WAKE ROBIN INN REDEVELOPMENT

104 & 106 SHARON ROAD & 53 WELLS HILL ROAD
SALISBURY, CONNECTICUT

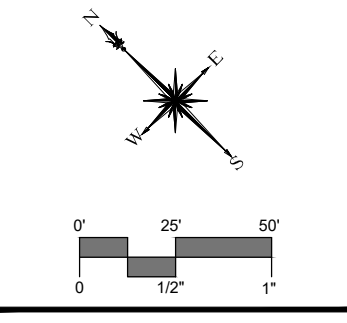
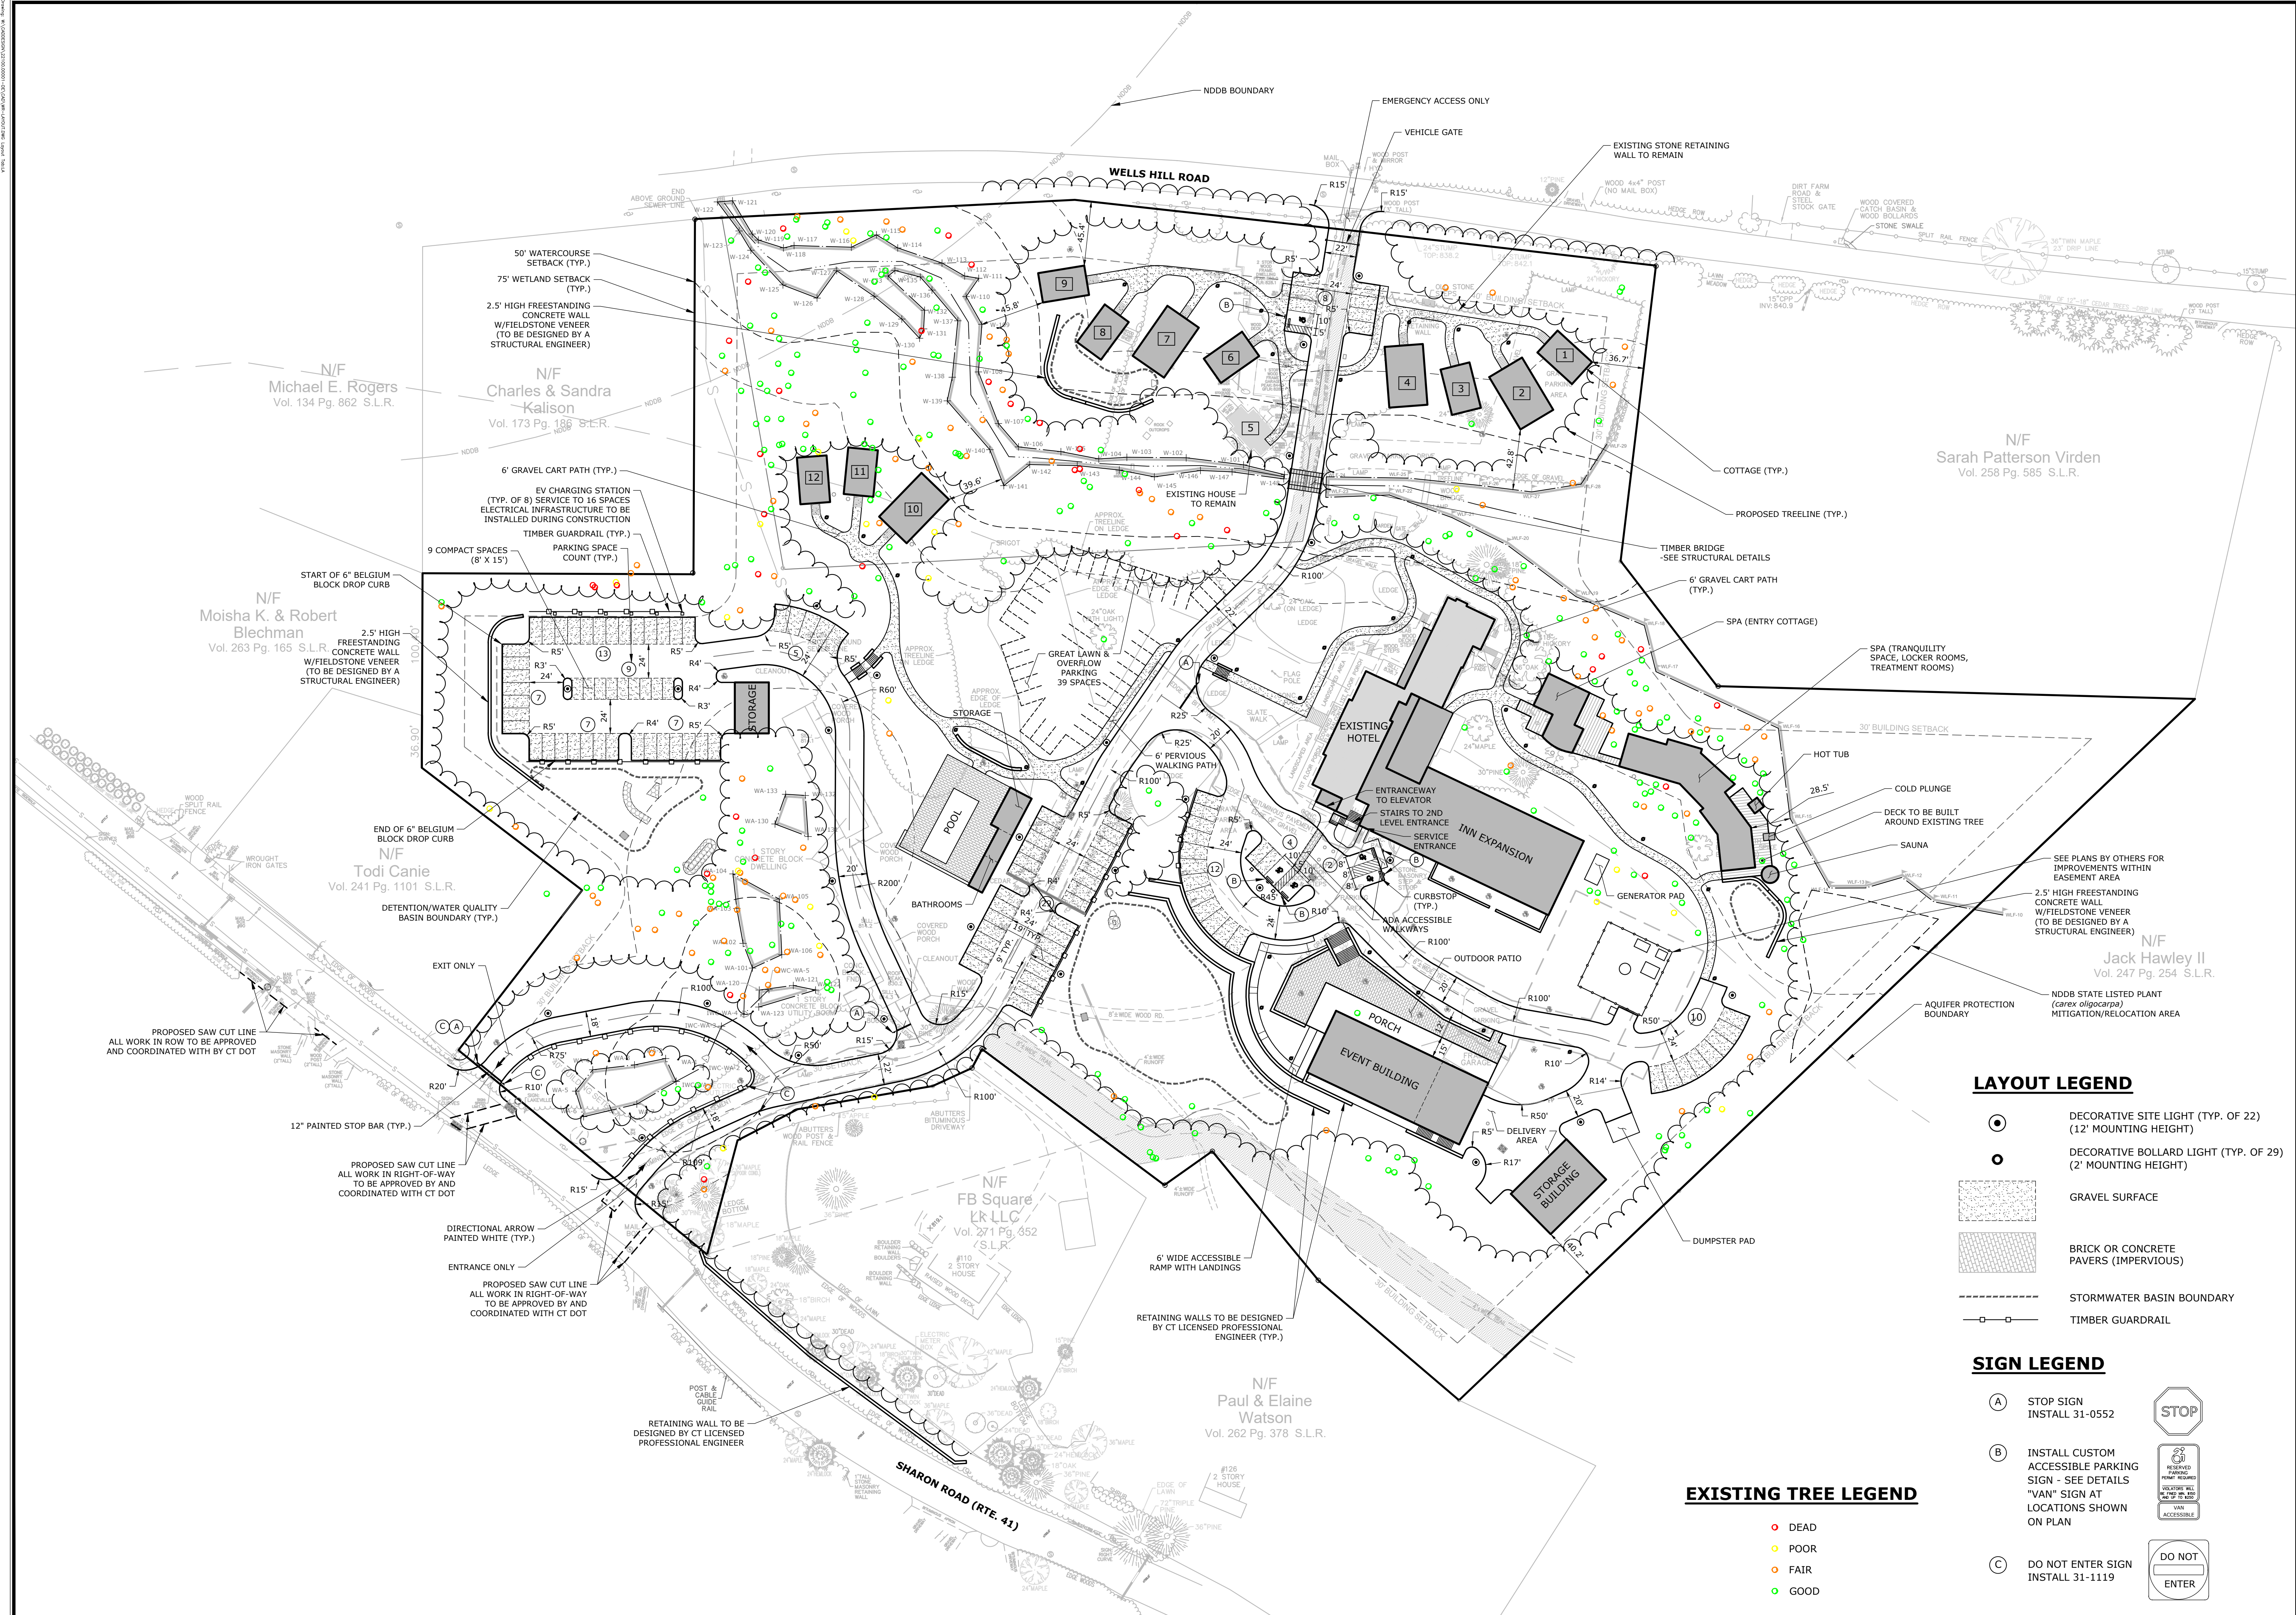
DESCRIPTION	DATE	BY
PAZ SUBMISSION	8/1/2024	SM
PEER REVIEW COMMENTS	8/6/2024	DSR
TOWN COMMENTS	11/6/2024	SM
PEER REVIEW COMMENTS	11/26/2024	SM
PUBLIC HEARING COMMENTS	12/9/2024	TDR

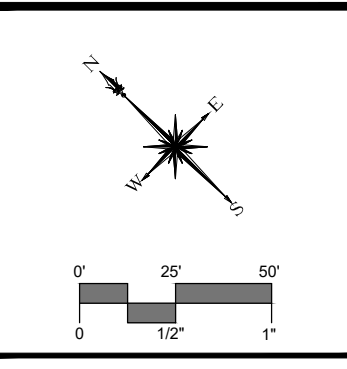
DESCRIPTION	DATE	BY
PAZ SUBMISSION	8/1/2024	SM
PEER REVIEW COMMENTS	8/8/2024	DSR
TOWN COMMENTS	11/6/2024	SM
PEER REVIEW COMMENTS	11/26/2024	SM
PUBLIC HEARING COMMENTS	12/9/2024	TDR

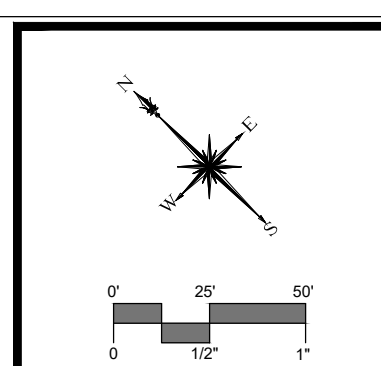
DESCRIPTION	DATE	BY
PAZ SUBMISSION	8/1/2024	SM
PEER REVIEW COMMENTS	8/6/2024	DSR
TOWN COMMENTS	11/6/2024	SM
PEER REVIEW COMMENTS	11/26/2024	SM
PUBLIC HEARING COMMENTS	12/9/2024	TDR

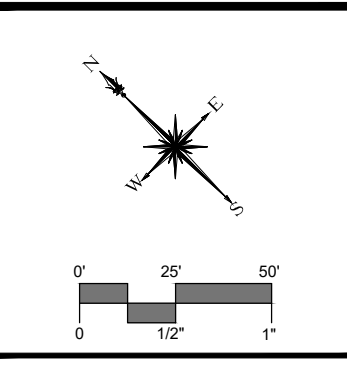
DESCRIPTION	DATE	BY
PAZ SUBMISSION	8/1/2024	SM
PEER REVIEW COMMENTS	8/8/2024	DSR
TOWN COMMENTS	11/6/2024	SM
PEER REVIEW COMMENTS	11/26/2024	SM
PUBLIC HEARING COMMENTS	12/9/2024	TDR
